Water Resources Department

SUBJECT: PERMIT AMENDMENT # 10322

Date: May 15 2007
To: Lisa Jaramillo - Water Right Transfer Section
From: Ivan Gall / Karl Wozniak , Hydrogeologists, Ground Water / Hydrology Section
Subject: Review of Transfer 10322, Leo Gentry Wholesale Nursery
03S/04E-6, 7, and 8

Prop = Proposed

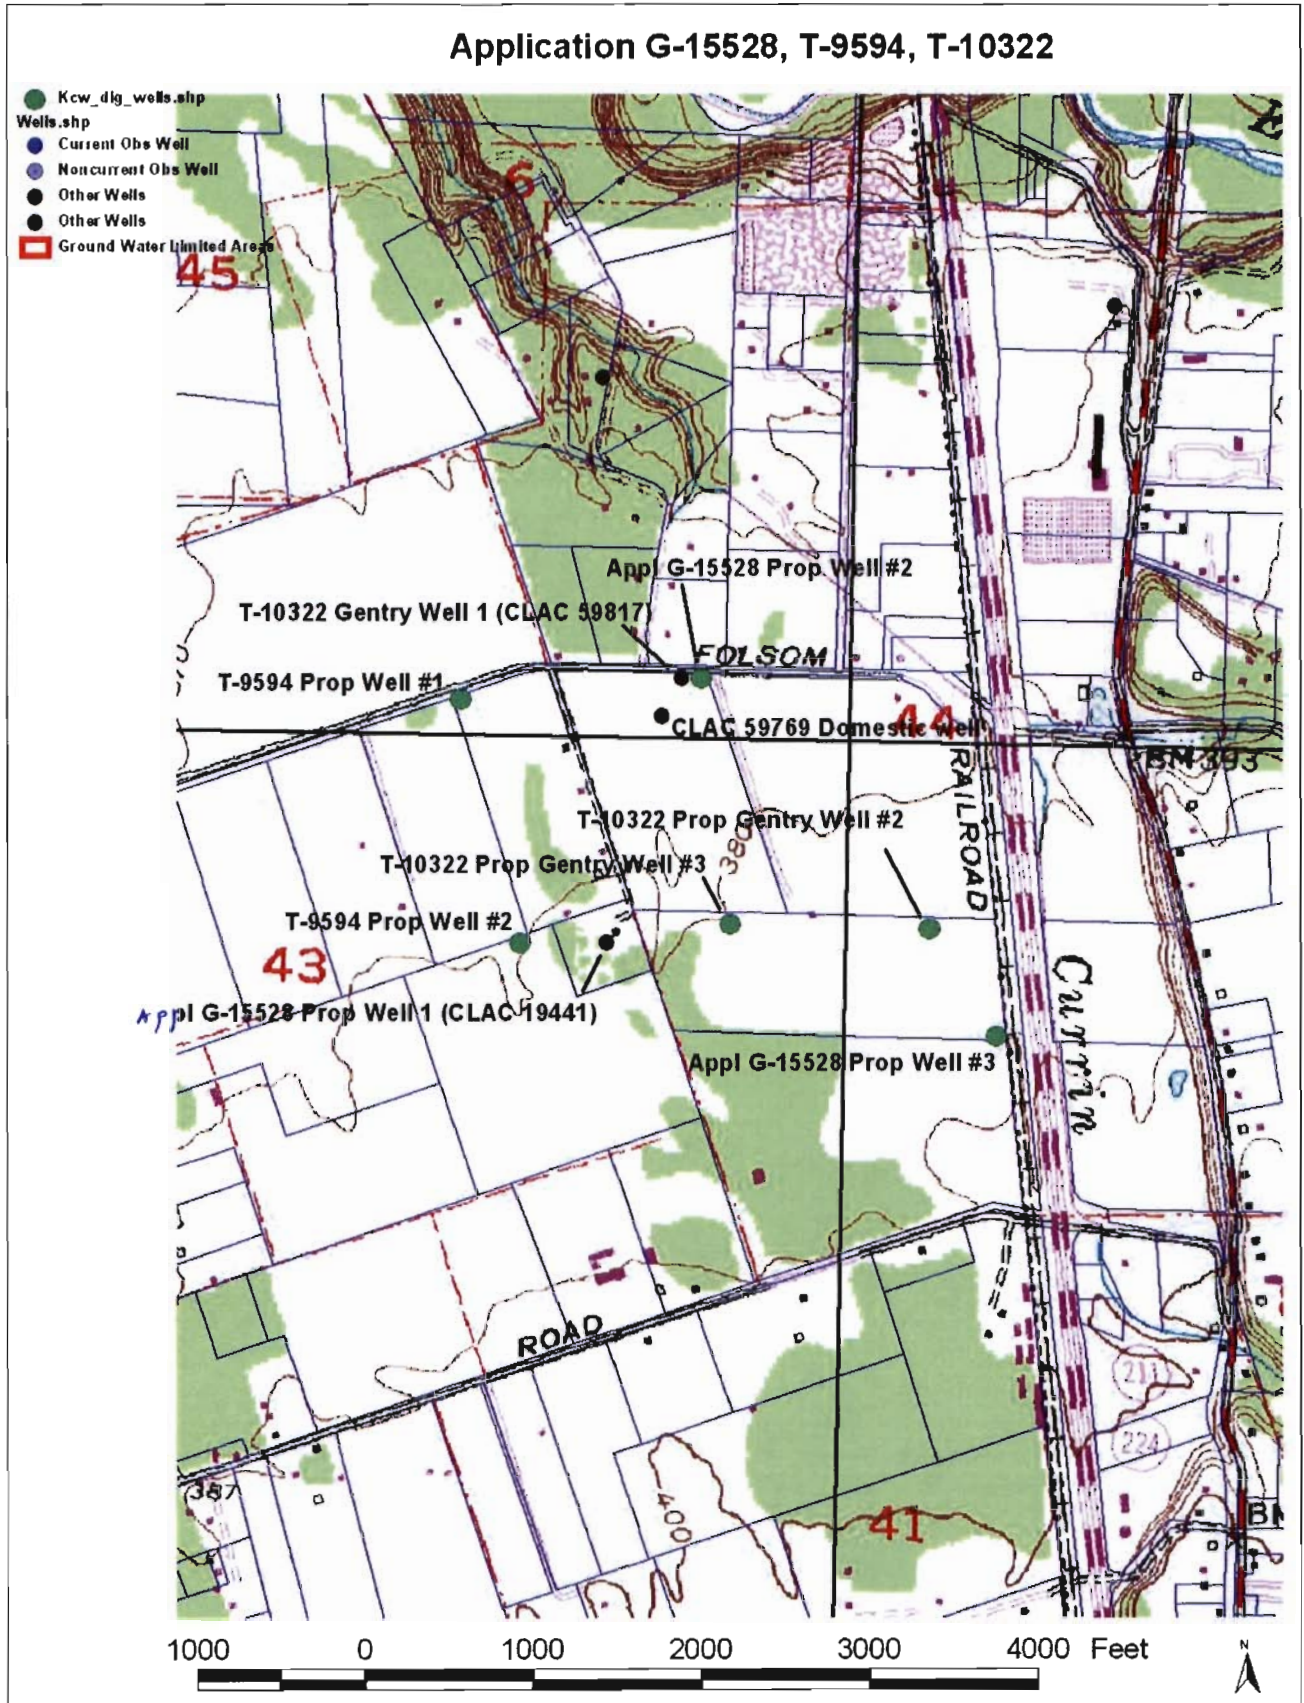
This is the second permit amendment application for permit G-15460. The permit originally listed three authorized points of appropriation (POAs). Wells were drilled at the approximate locations of two of these POAs, CLAC 19441/57291 near the location for POA 1 and CLAC 59817 near the location for POA 2. The first amendment, filed under T-9594, resulted in special order 58-333 (December 10, 2003) which replaced the three original POAs with two new POAs (now assigned to Komsart & Jennifer Rattanapai). Unfortunately, the intent of the permit amendment was to add two POAs, as clearly specified in the Application for a Permit Amendment. The current permit amendment, T-10322 (received February 20, 2007), recognizes that only two POAs are now listed on the permit, but incorrectly identifies the authorized locations for these POAs as those specified for POA 2 and 3 on the original permit. T-10322 proposes to change the locations of these two POAs and to add a third POA. This would have the effect of incorrectly removing the only two authorized POAs on the permit, those that are specified on special order 58-333. This problem can be resolved by having the applicant submit a revised Permit Amendment Application that correctly specifies the authorized POAs and that applies for three additional POAs. If these corrections are made and this transfer is approved, the net effect will be to have 5 authorized POAs on the permit, two under the name of Komsart & Jennifer Rattanapai and three under the name of Leo Gentry Wholesale Nursery, Inc. An attached map shows POA locations as proposed on the original permit G-15460 and on permit amendment applications T-9594, and T-10322.

Since the proposed wells are not significantly closer than the original permitted POAs to nearby streams, hydraulic interference with local streams is not likely to be increased by the changes proposed on this permit amendment. Therefore, nearby surface water sources should be adequately protected from substantial interference if the new wells are limited to ground water production from no shallower than 100 feet below land surface, as specified on the original permit.

- The Application for a Permit Amendment is corrected to show the two authorized POAs, as noted in the discussion section below
- The Application is revised to specify the addition of three POAs, not the replacement or change of the two authorized POAs
- All original conditions on the permit are applied to the new POAs, and
- The order approving the transfer specifies that any new wells that produce ground water from the Columbia River Basalt Group aquifer shall be limited to a single aquifer and shall not simultaneously produce water from the Troutdale or Rhododendron Formations.
